**LEBANON PLANNING BOARD
AUGUST 12, 2024 - 6:30 PM
COUNCIL CHAMBERS, CITY HALL OR
REMOTE VIA VIRTUAL PLATFORM
LEBANONNH.GOV/LIVE**

- A. **Brickyard One Nominee Trust, 174 Hanover Street (Tax Map 48, Lot 4), 0 Hanover Street (Tax Map 48, Lot 2), 0 Hanover Street (Tax Map 48, Lot 1), and 238 Hanover Street (Tax Map 63, Lot 1), zoned R-1, R-O-1, R-3 & RL-3:** Request for Site Plan Review and a Conditional Use Permit pursuant to Sections 308.2, 310.2, 311A.2, and 501.2 of the Zoning Ordinance for a proposed 474-unit multi-family Planned Unit Residential Development (PURD) totaling +/- 731,600 sq. ft. in size, consisting of 11 buildings together with parking, utilities, landscaping, access, and other related site improvements. Applicant also requests a Conditional Use Permit pursuant to Section 308.4 of the Zoning Ordinance to allow an increase in the maximum permitted building height from 45 ft. to 55 ft. **PB2024-22-CUPSPR - Continued from July 8, 2024**

**RE: July 8, 2024 Planning Board Meeting - Agenda Item 4.A
Marlee Dixon/Greg Hagley Appeal of Impact Fee Assessment -
78 Bank Street (Tax Map 92, Lot 106), Zoned R-O**

C2.0

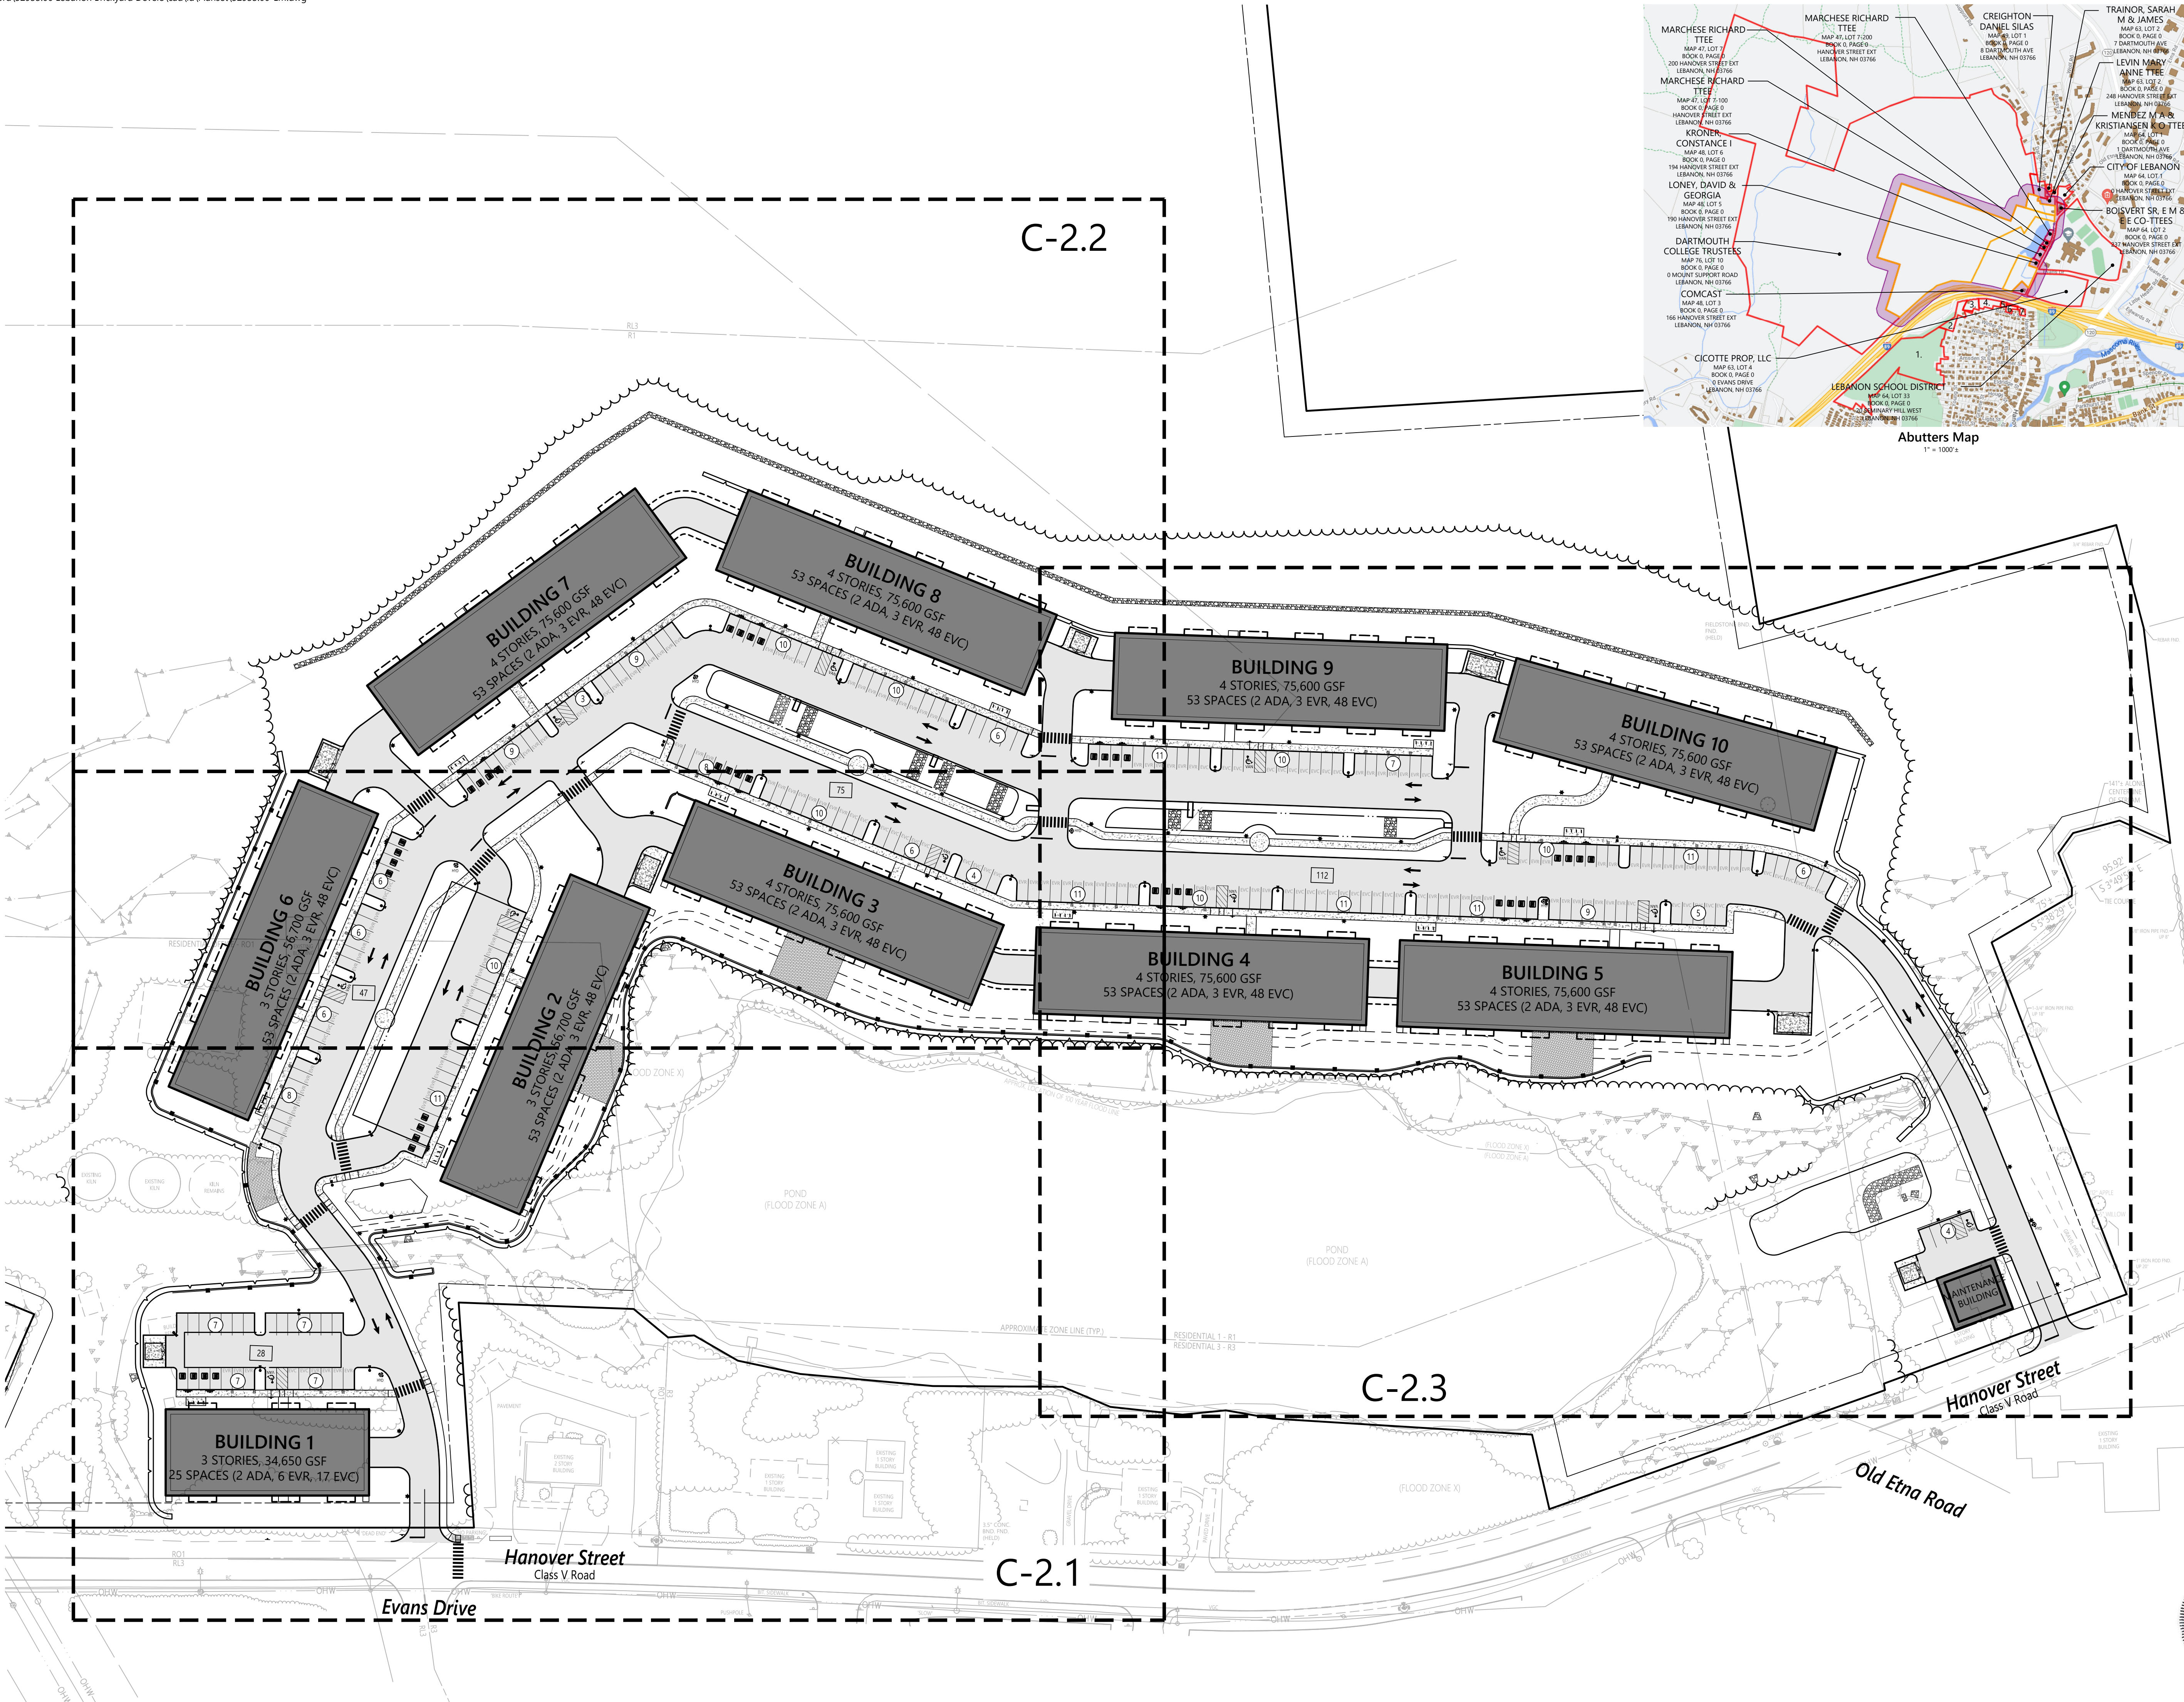
5. As conveniently shown on Sheet C2.0, site driveways at Hanover Street near both the southerly and northerly ends of the development parcel with interior drives connecting the two. While we fully support this approach, given the high residential density served, we recommend consideration of designating paired parallel drives between Buildings 3 & 4 and Buildings 8 & 9 for one-way travel (easterly drive northbound; westerly drive southbound). In our view, enhanced vehicular and pedestrian safety could be realized by elimination of need for parked vehicle backing movements into two directional traffic along the fronts of these four buildings.

7. Close examination of Sheet C2.0 reveals garage access/egress at Building 4 will necessitate travel through garages at either Building 3 or Building 5. While we do not view this as problematic, this fact may influence the timing of construction of individual buildings and adjoining infrastructure.

9. A note provided on Sheet C2.0 cites the fact that access to public transit is presently available near the intersection of Heater Road and Old Etna Road; approximately 0.2 miles from the development site. That said in correspondence dated May 13th, the applicant's consultant acknowledges that "with the additional ridership resulting from this project, there is potential to coordinate future stops." We suspect this prediction may prove to be accurate. To that end we recommend the applicant consider expanding the final site plan to identify a location suitable for such future accommodation at or near one or both proposed site driveways. While we are not suggesting constructing any permanent improvement(s) at this time, we believe it may be wise to at least pre-plan for this potential eventuality at this time.

Comment 5. *"As conveniently shown on Sheet C2.0, site driveways at Hanover Street near both the southerly and northerly ends of the development parcel with interior drives connecting the two. While we fully support this approach, given the high residential density served, we recommend consideration of designating paired parallel drives between Buildings 3 & 4 and Buildings 8 & 9 for one-way travel (easterly drive northbound; westerly drive southbound). In our view, enhanced vehicular and pedestrian safety could be realized by elimination of need for parked vehicle backing movements into two directional traffic along the fronts of these four buildings."*

Comment 7. *"Close examination of Sheet C2.0 reveals garage access/egress at Building 4 will necessitate travel through garages at either Building 3 or Building 5. While we do not view this as problematic, this fact may influence the timing of construction of individual buildings and adjoining infrastructure."*

Comment 9. *"A note provided on Sheet C2.0 cites the fact that access to public transit is presently available near the intersection of Heater Road and Old Etna Road; approximately 0.2 miles from the development site. That said in correspondence dated May 13th, the applicant's consultant acknowledges that "with the additional ridership resulting from this project, there is potential to coordinate future stops." We suspect this prediction may prove to be accurate. To that end we recommend the applicant consider expanding the final site plan to identify a location suitable for such future accommodation at or near one or both proposed site driveways. While we are not suggesting constructing any permanent improvement(s) at this time, we believe it may be wise to at least pre-plan for this potential eventuality at this time."*

Comment 10. *"We note Sheets C2.0 and C2.1 currently depict proposed installation of pavement markings permitting either left or right exiting turning movements at the northerly site driveway. Since the proposed site driveway is situated directly opposite Evans Drive, we recommend elimination of this pavement marking as the Traffic Impact Study suggests significant volumes of traffic operating through the northerly site driveway seek eastbound travel on Evans Drive."*

Response: The arrows shown on the site plans are an indication of vehicular circulation direction only, in response to another comment received. VHB's believes the comment references the southerly driveway as it is opposite Evans Drive, and as such has removed the arrows at both proposed driveway and Hanover Street intersections. See sheet C2.0 and C2.1.

C2.2

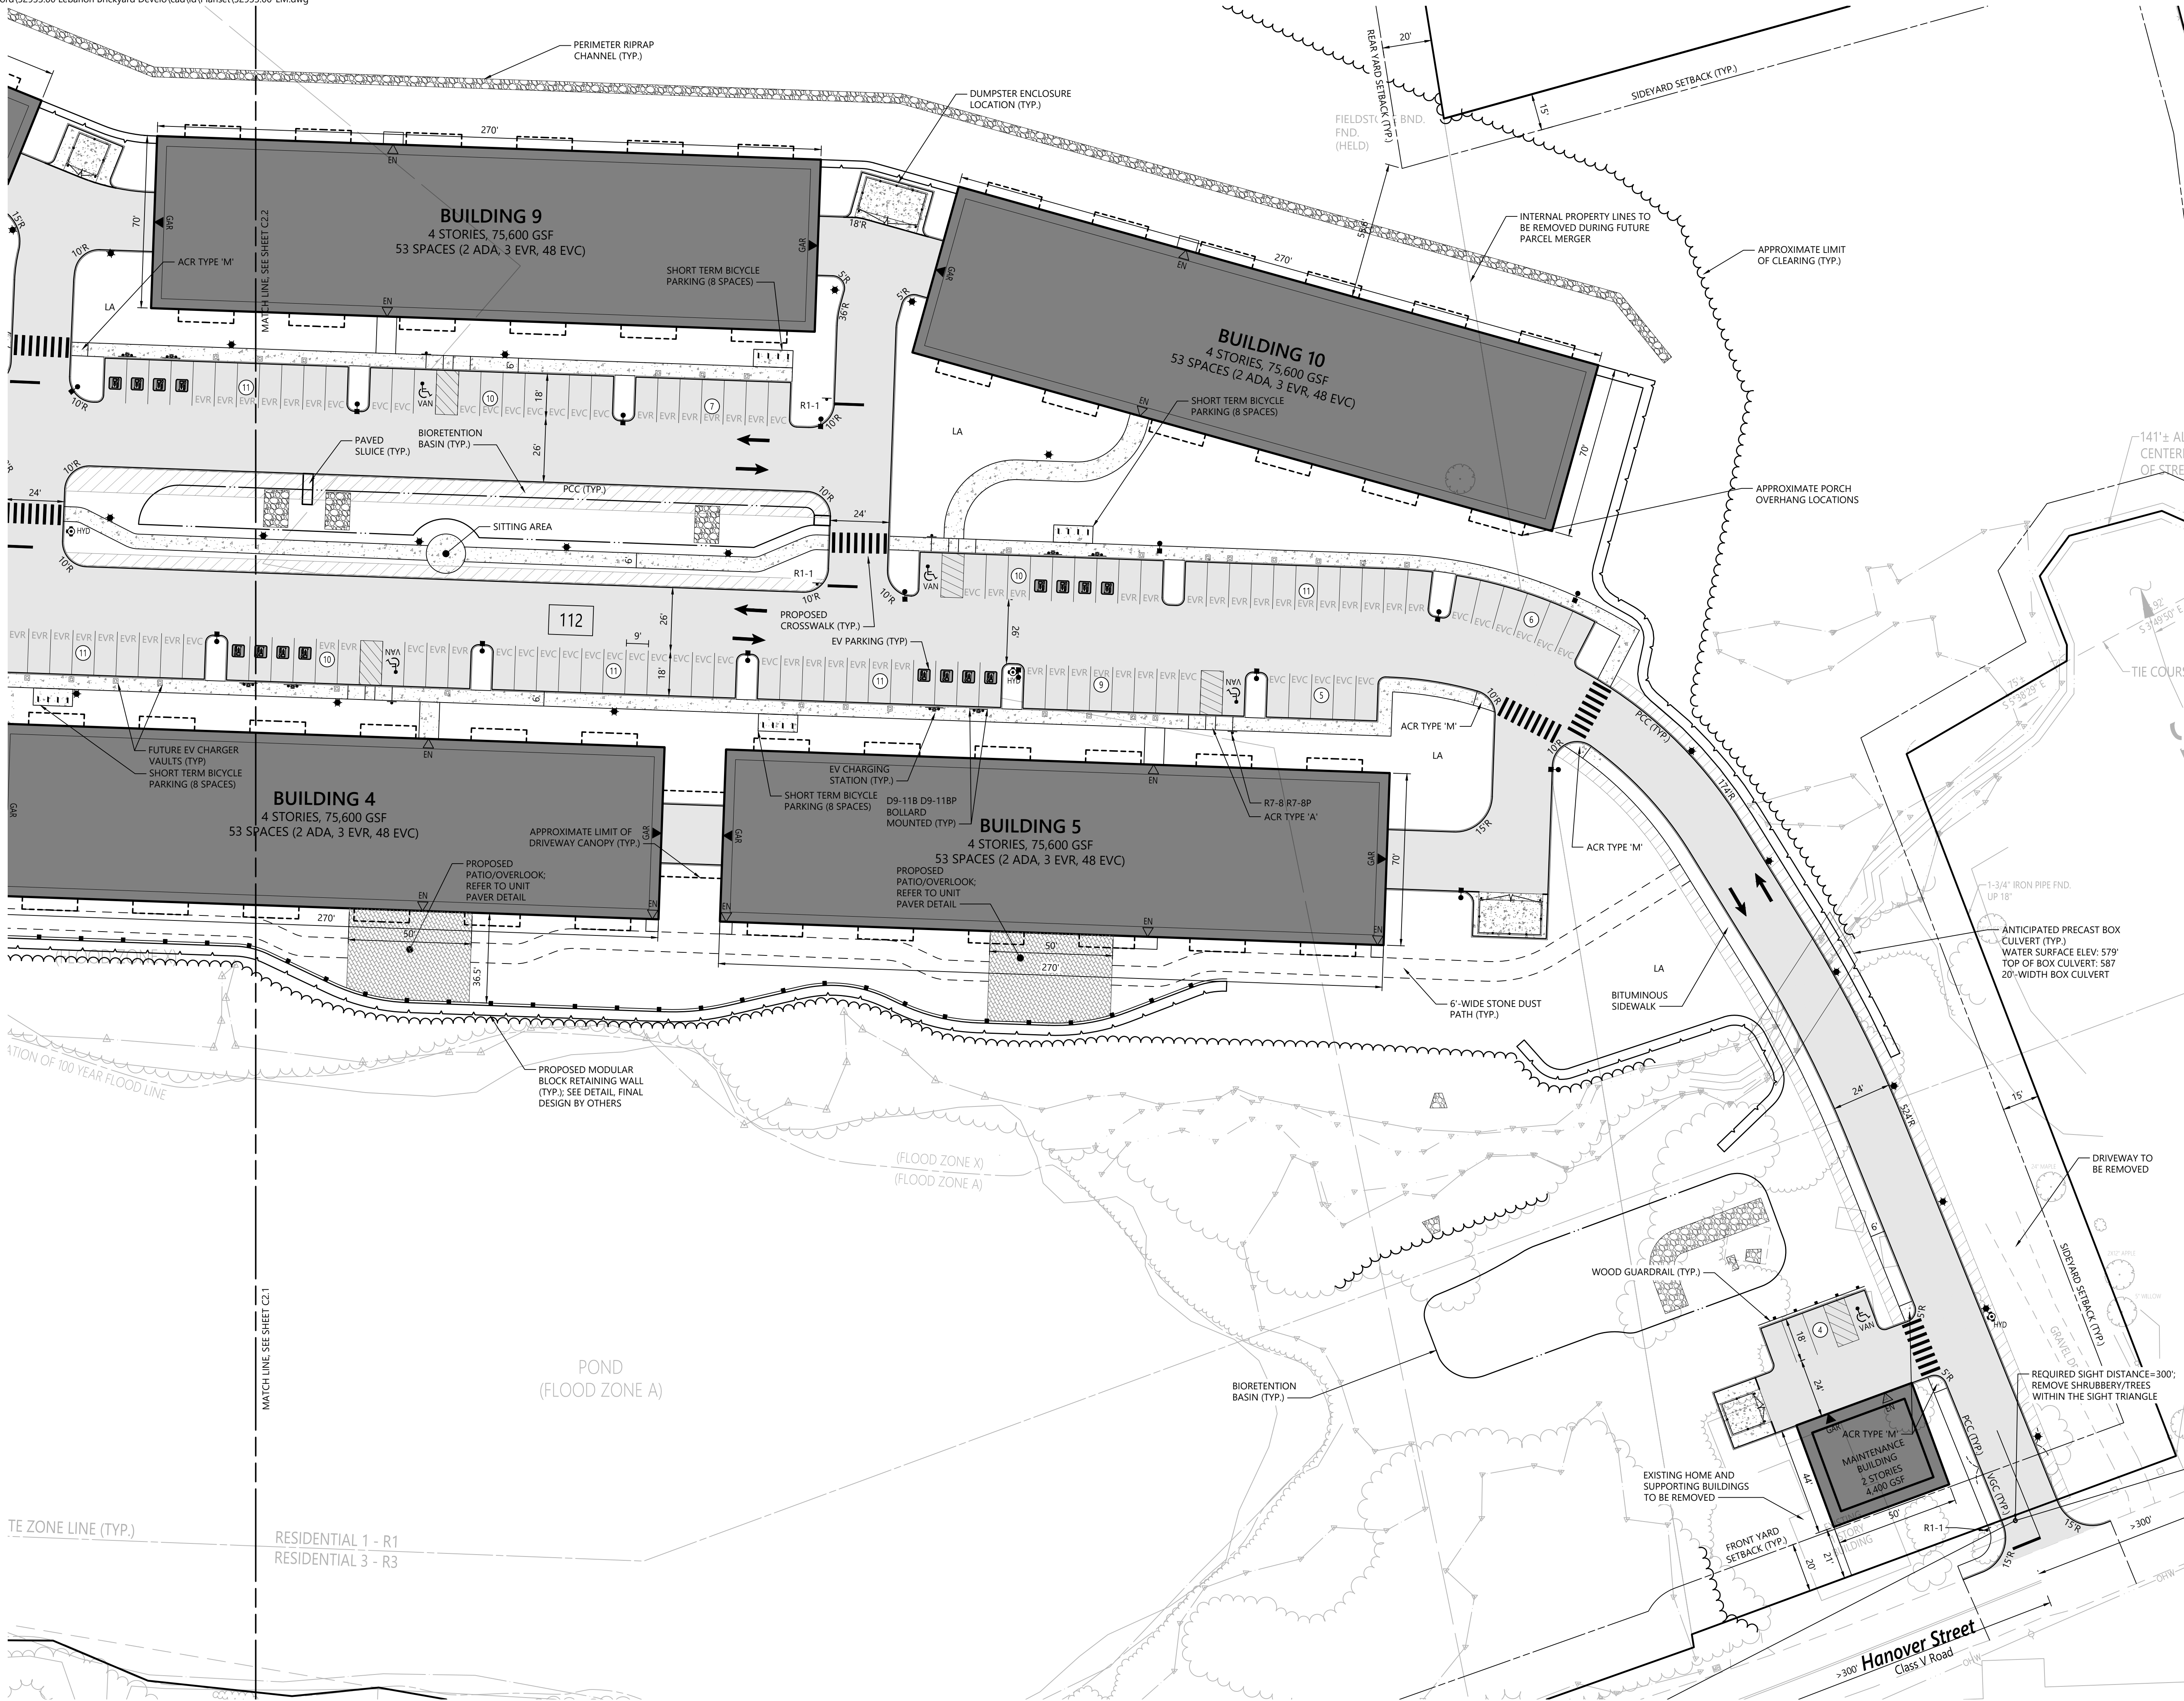
14. Sheet C2.2 identifies a typical accessible parking sign by MUTCD designation R7-1. We believe the correct designation is R7-8.
15. Similarly, Sheet C2.2 identifies a typical EV charging station location by use of signage corresponding with MUTCD designations D-11B and D-11BP. We believe the correct references are D9-11B and D9-11BP.

Comment 14. *"Sheet C2.2 identifies a typical accessible parking sign by MUTCD designation R7-1. We believe the correct designation is R7-8."*

Comment 15. *"Similarly, Sheet C2.2 identifies a typical EV charging station location by use of signage corresponding with MUTCD designations D-11B and D-11BP. We believe the correct references are D9-11B and D9-11BP."*

Response: The Sign Summary on sheet C2.1 has been updated.

Response: The Sign Summary on sheet C2.1 has been updated.
